Wisconsin Department of Transportation

Proposal #44: 8680-00-71, WISC 2016 503
City of Superior, Belknap Street
Banks Avenue – Hill Avenue
USH 2
Douglas County

This is Addendum No. 01, which provides for the following:

ADDENDUM NO. 01

Addendum No. 01
ID 8680-00-71
Revised Sheet 19
December 5, 2016

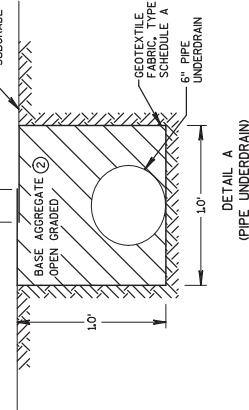
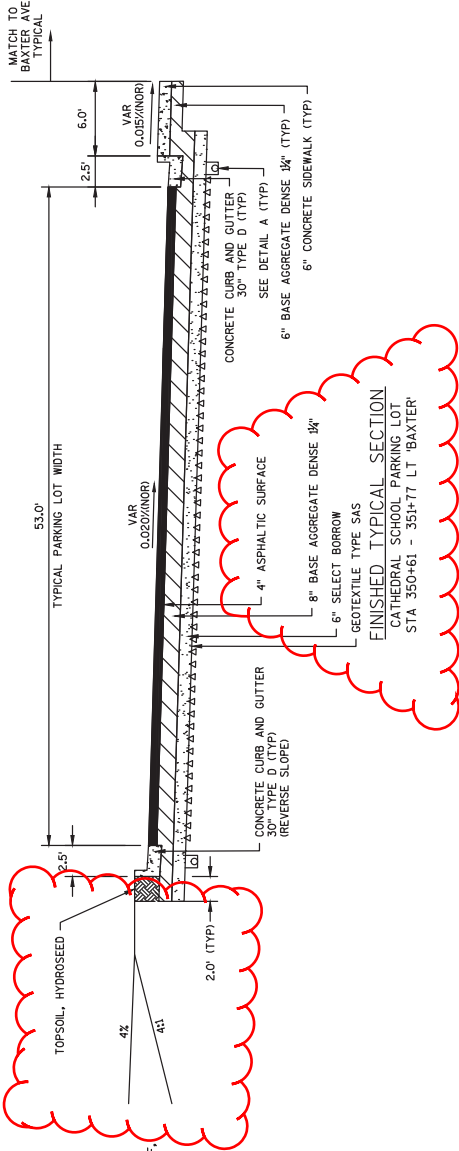
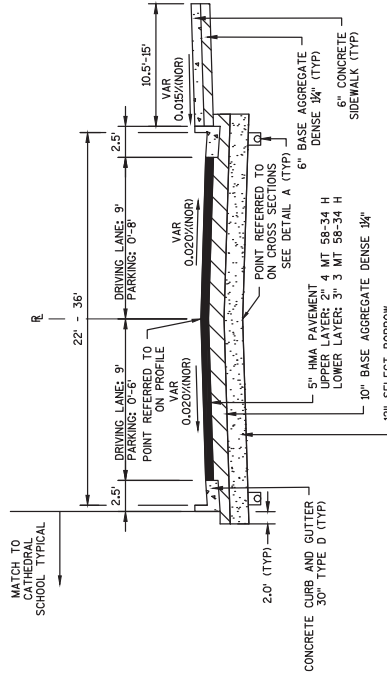
Revised Plan Sheets	
Plan Sheet	Plan Sheet Title (brief description of changes to sheet)
19	Revised Typical Section: Revised and combined with Typical from Sheet 20
30	Revised Typical Section for Cathedral Parking Lot West side of Baxter Avenue
34	Revised Construction Detail, missing data placed
63	Intersection Detail: Added Removing Fence, removed elevation label

Addendum No. 01
 ID 8680-00-71
 Added Sheet 41B
 December 5, 2016

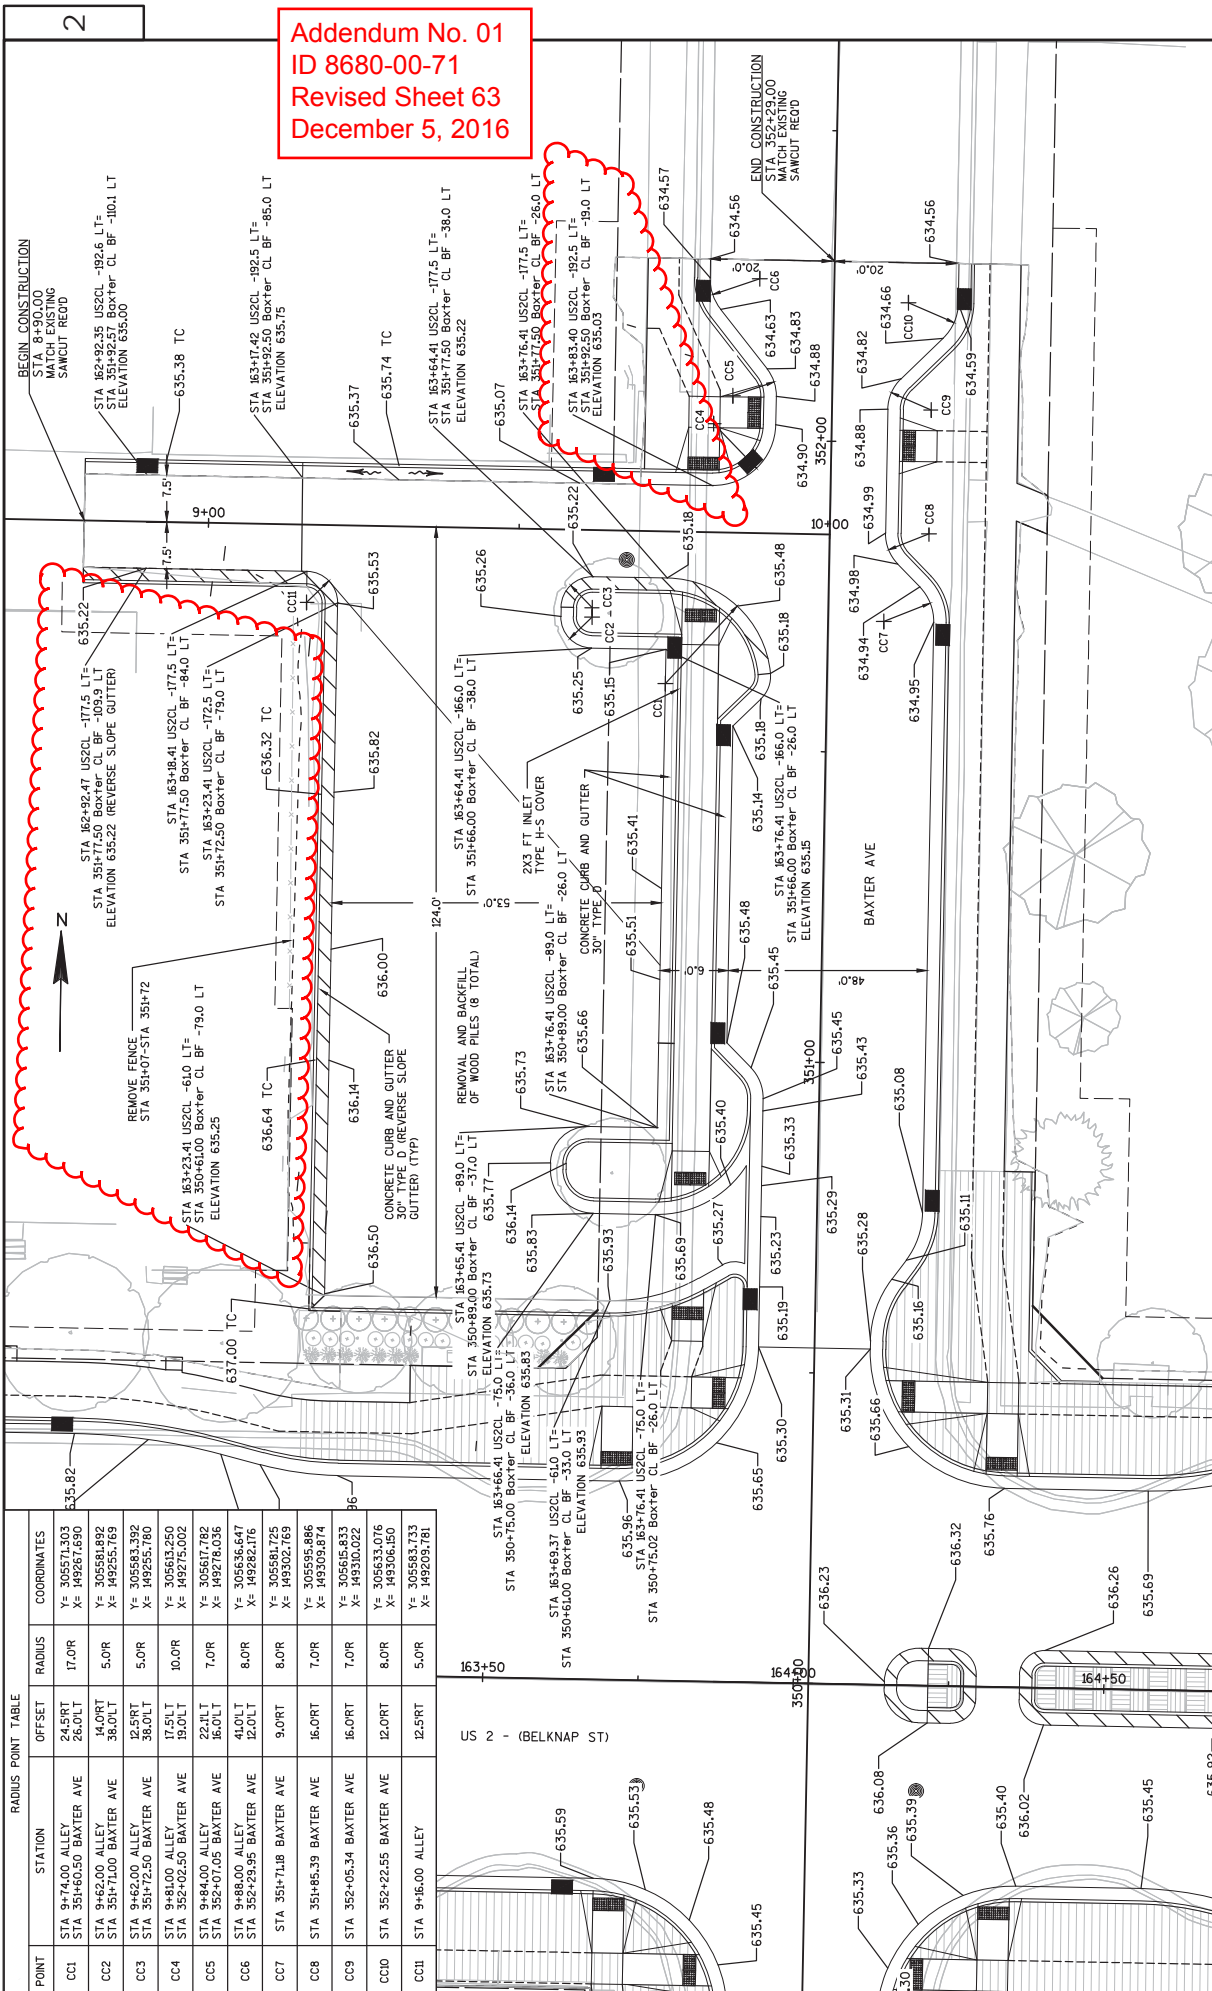
Added Plan Sheets	
Plan Sheet	Plan Sheet Title (brief description of why sheet was deleted)
41A	Construction Detail Added to show Knee Wall Detail
41B	Construction Detail Added to show Landscape edging details
168A	Sanitary Sewer Detail Added
427A	Temporary Signing Sheet – No parking on Tower Avenue Added
519A	MQ Sheet: Revised Asphaltic Surface, Select Borrow and Base Aggregate Quantities
558A	MQ Sheet: Added New MQ Sheet for New Item Concrete Knee Wall, Removing Fence, Additional Traffic Control Items on Tower Avenue, Lighting Item revisions
709A	SDD 9C12 Sheet a: Added detail needed for traffic signal plans
709B	SDD 9C12 Sheet b: Added detail needed for traffic signal plans

Addendum No. 01
 ID 8680-00-71
 Revised Sheet 250
 December 5, 2016

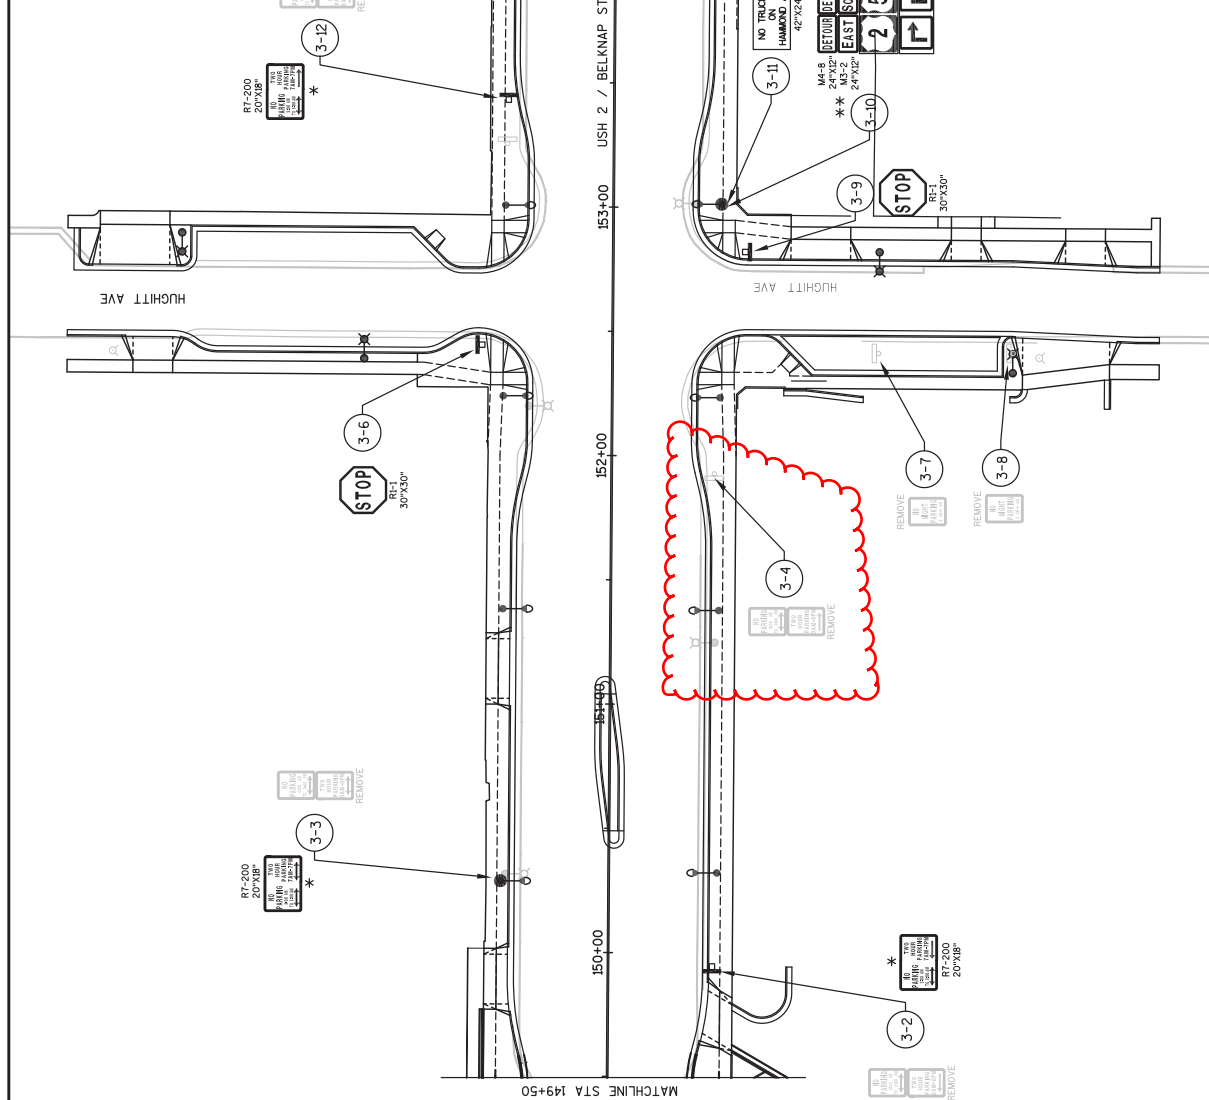
153	Water main Plan and Profile: revisions made to one line
250	Permanent Signing Sheet: Parking Signs removed, added in new location
265	Lighting Plan Sheet: Added Note for Lighting Sign
270	Lighting Plan Sheet: Added Note for Lighting Sign
276	Lighting Detail Sheet: Added Detail for Lighting Unit Type Special 4
279	Lighting Detail Sheet: Added Detail for Lighting Unit Type Special 5
411	Pavement Marking Sheet: Bus Turnout Removed, and Bus Turnout Shifted
507	MQ Sheet: Revised to add Unusable Cut volumes, added additional excavation for parking lots and driveways
508	MQ Sheet: Revised to add Unusable Cut volumes, added additional excavation for parking lots and driveways
518	MQ Sheet: Revised – Rearranged Asphaltic Surface Temporary Quantity tables
519	MQ Sheet: Revised Asphaltic Surface, Select Borrow and Base Aggregate Quantities
537	MQ Sheet: Revisions made to add parking signs and revised bus turnouts
